# BUCKHEAD 3RD ADDITION

Re: S/D 98-18 -- Final Plat of BUCKHEAD 3RD ADDITION

At the regular meeting of the Subdivision Committee of the Metropolitan Area Planning Commission on Thursday, March 5, 1998, the above captioned plat was considered. The action of the Committee was to approve the final plat, subject to the following:

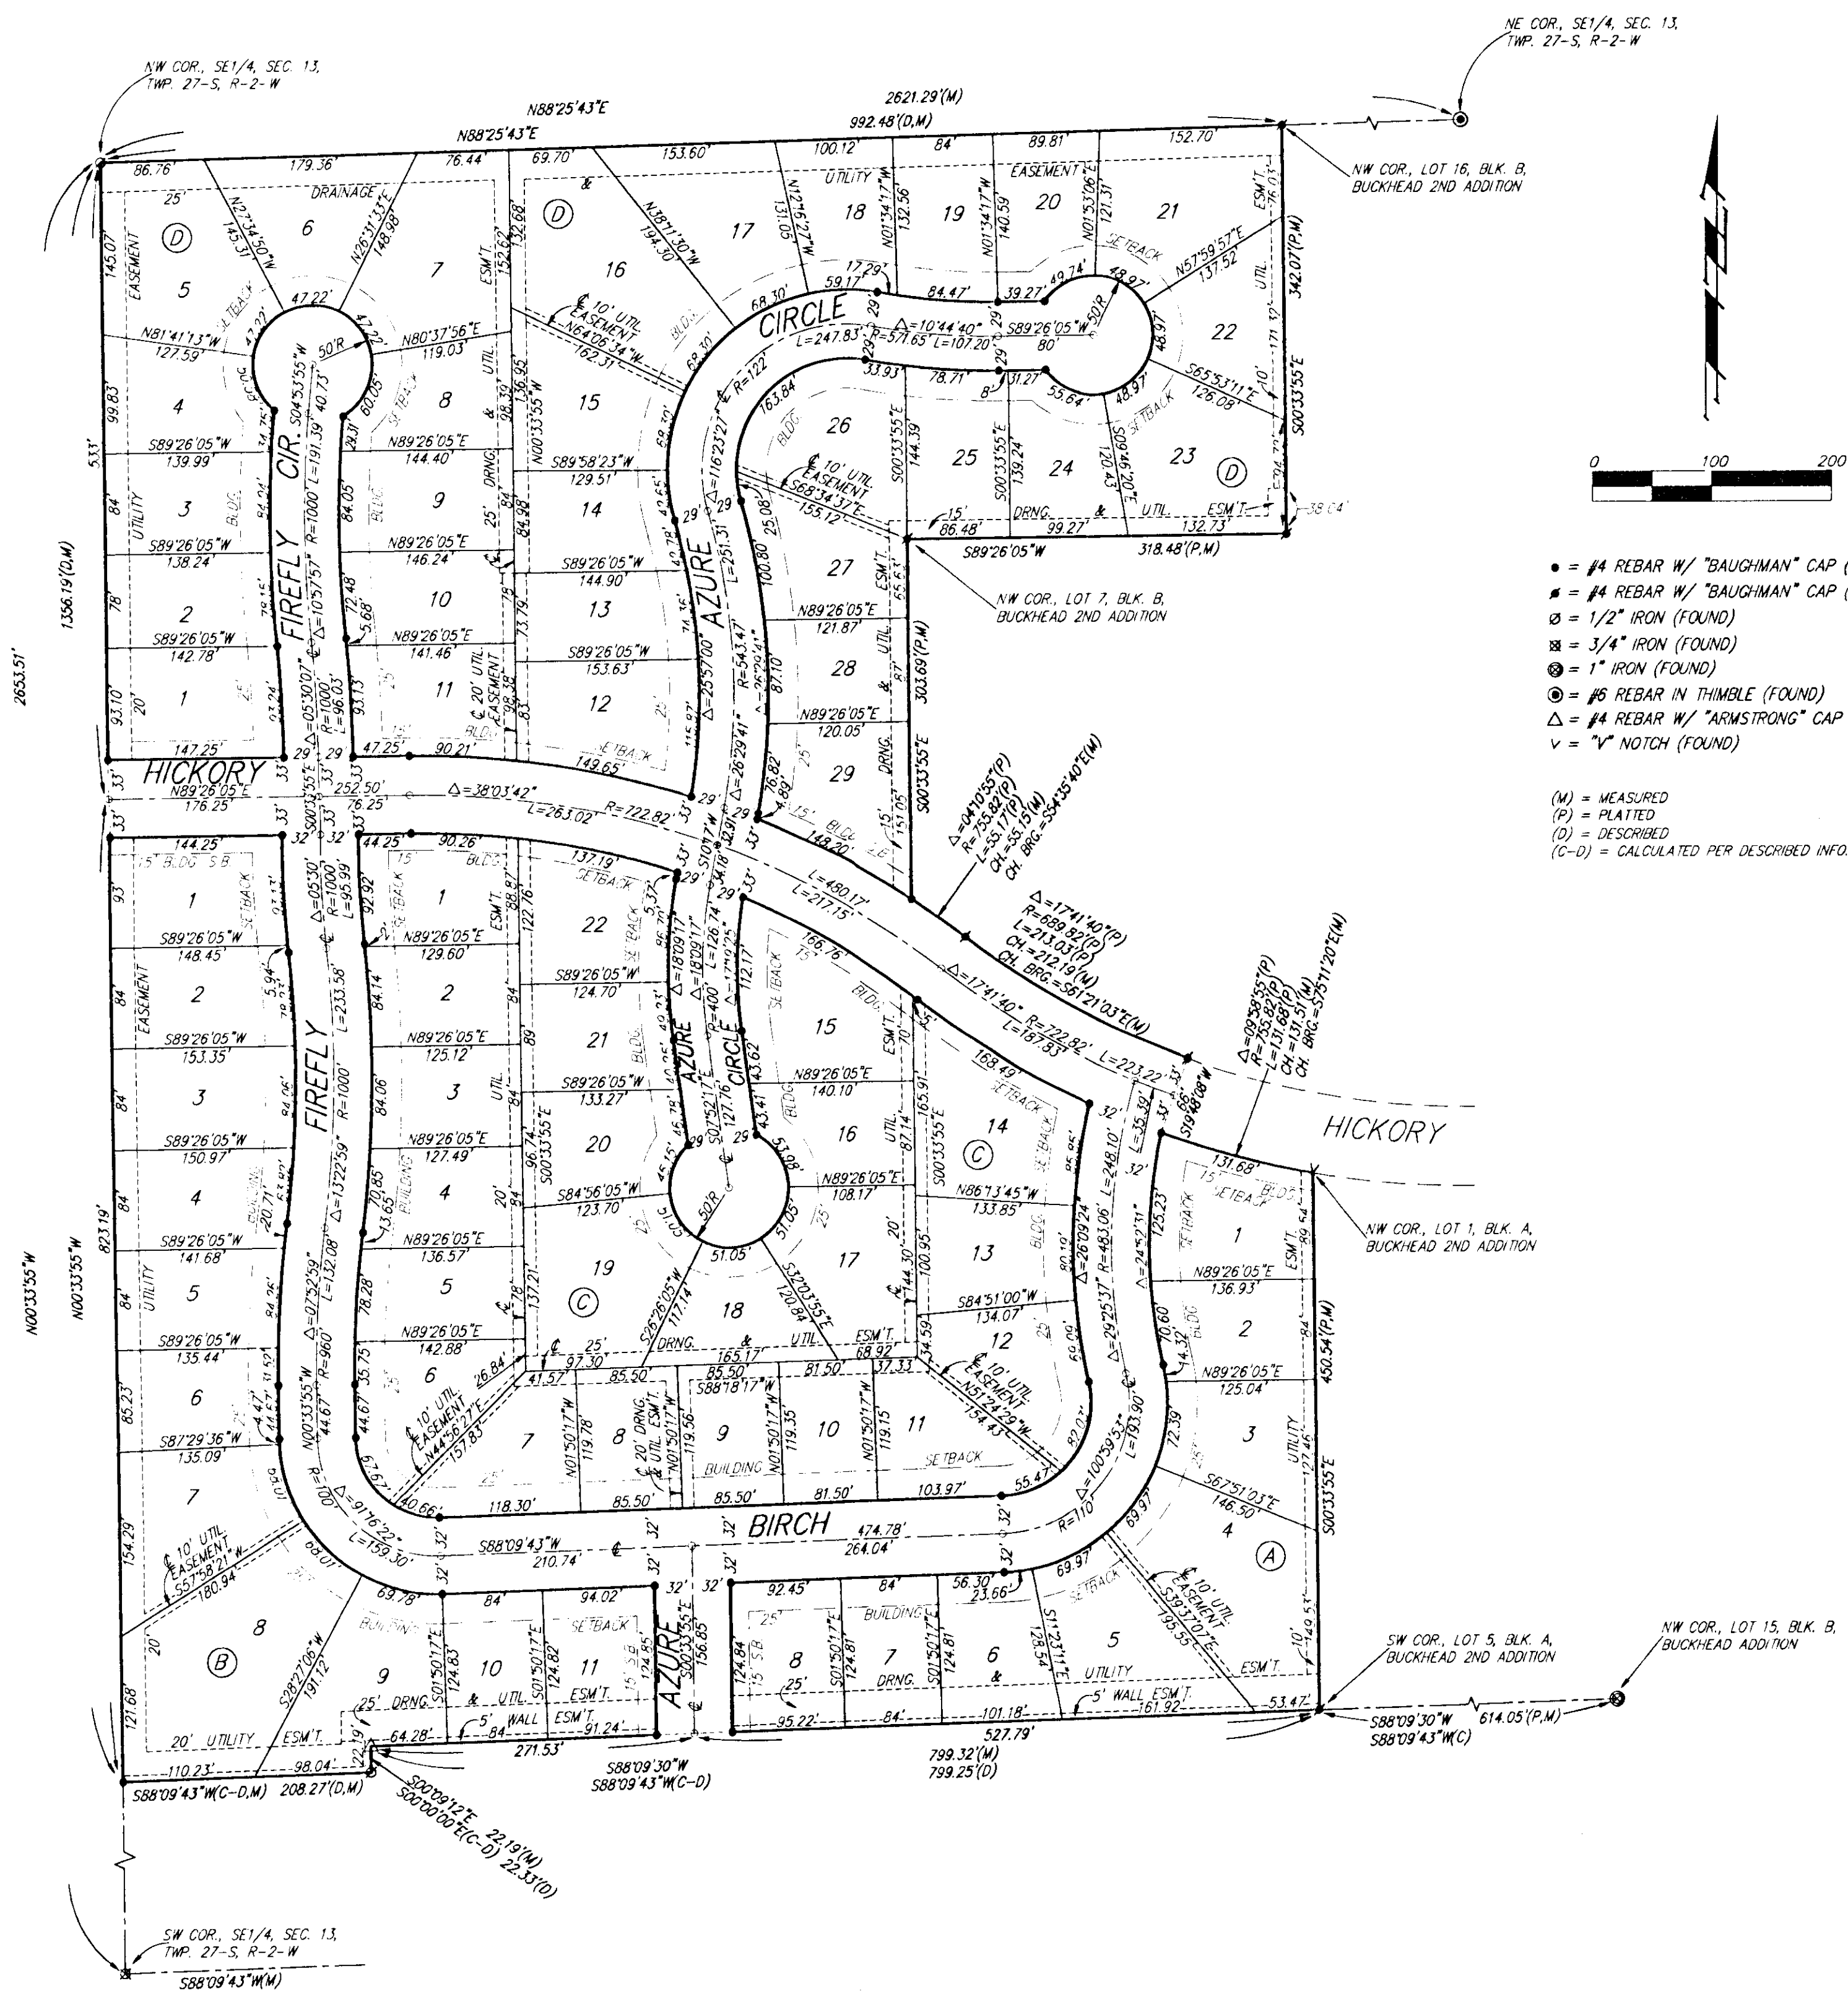
- C. **City Engineering** needs to comment on the status of the applicant's drainage plan. *The drainage plan is approved. Wherever storm sewer, sanitary sewer and other utilities share an easement, it is requested that the width of the easement be increased to 25 feet.*

- D. The applicant shall guarantee the paving of the proposed interior streets. This guarantee shall include the paving of Hickory to a collector status. Sidewalks shall be included in the guarantee providing for sidewalks on both sides of Hickory, and one side of the looped street Birch-Firefly.

*Firefly Court should be renamed Firefly Circle as it is a continuation of Firefly. Both streets named Azure Court should be renamed Azure Circle as they are extensions of Azure to the north.*

- F. The applicant shall submit a covenant which provides for four (4) off-street parking spaces per dwelling unit on each lot which abuts a 58-foot street. The covenant shall inventory the affected lots by lot and block number and shall state that the covenant runs with the land and

- G. ✓ The platting binder shows that the site's ownership is in the party of "Kelsey Development, Inc". This name must appear on the owner's signature block on the final plat tracing.

- I. The applicant's engineer is advised that the Register of Deeds is requiring the name(s) of the notary public, who acknowledges the signatures on this plat, to be printed beneath the notary's signature.

- N. The representatives from the utility companies should be prepared to comment on the need for any additional utility easements to be platted on this property. **The representative from KG&E has requested additional easements.**
